**Griffith Park
Community Centre,
Bankstown**

**Transport Impact
Assessment.**

A Request for Information (RFI) was received from Canterbury-Bankstown Council on 22nd September 2025 (Ref: PAN-555420).

Table 1: RFI's Response

6.1. On-Street Parking – Dale Parade

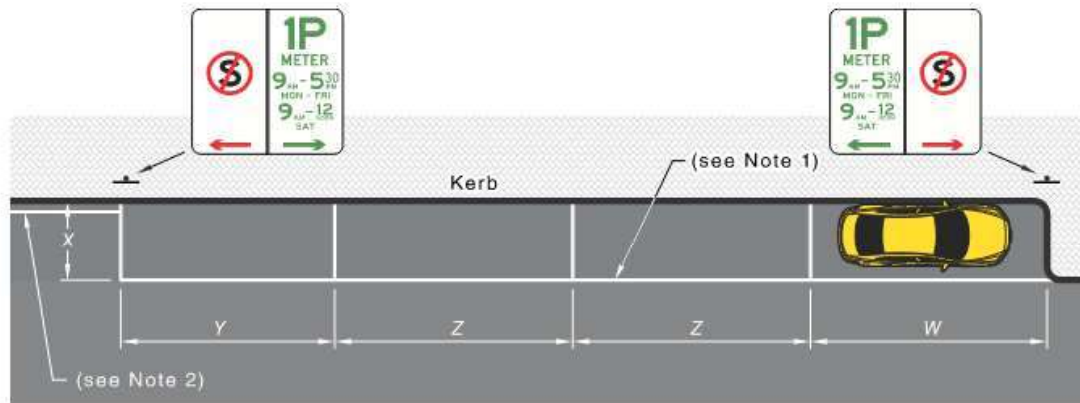
RFI Traffic	Council Comment / Requirement	ptc. response														
RFI-01	Please provide an explanation or clarification as to why the number of spaces that exist along Dale Parade are proposed to be reduced.	<p>The reduction of parking spaces along Dale Parade is in the spirit of the Complete Streets principles, which aim to improve safety, streetscape quality, and community amenity. The reconfiguration from angled to parallel parking supports broader public-domain works associated with the community centre, including wider pedestrian paths, improved landscaping, and enhanced visibility near the crossing.</p> <p>To understand existing kerbside use, ptc. undertook an on-site observation survey between 7:00 am and 8:00 am on 9 October 2025, focusing on the Dale Parade frontage. This period was selected based on industry experience as the typical peak hour for loading and servicing activity prior to nearby shops and businesses opening for morning trade. Both parking and loading activity were observed during this period, confirming that approximately three to four spaces are regularly used for loading and unloading rather than long-stay parking. The results are summarised below.</p>

The existing angled parking along Dale Parade is proposed to be reconfigured as parallel parking to improve traffic safety and alignment with the upgraded public domain layout. These spaces should be designed in accordance with AS 2890.5:2020 – On-Street Parking, which sets out the minimum length and width dimensions for standard public roadside parking bays.

An on-site observation survey was undertaken between 7:00 am and 8:00 am on 9 October 2025, focusing on the frontage of Dale Parade. This period was selected as it represents the typical peak hour for loading and servicing activity before nearby businesses open for morning trade. Both parking and loading behaviours were observed during this time, confirming that approximately three to four spaces are regularly used for loading and unloading rather than long-stay parking.

To maintain turnover and offset the reduction in total spaces, **ptc.** proposes converting the remaining five standard spaces along Dale Parade from 1P to ¼P (15-minute) parking. This would enable up to four vehicles per space per hour, providing an equivalent functional capacity to support business operations and short-term deliveries while aligning with Council's broader streetscape vision.
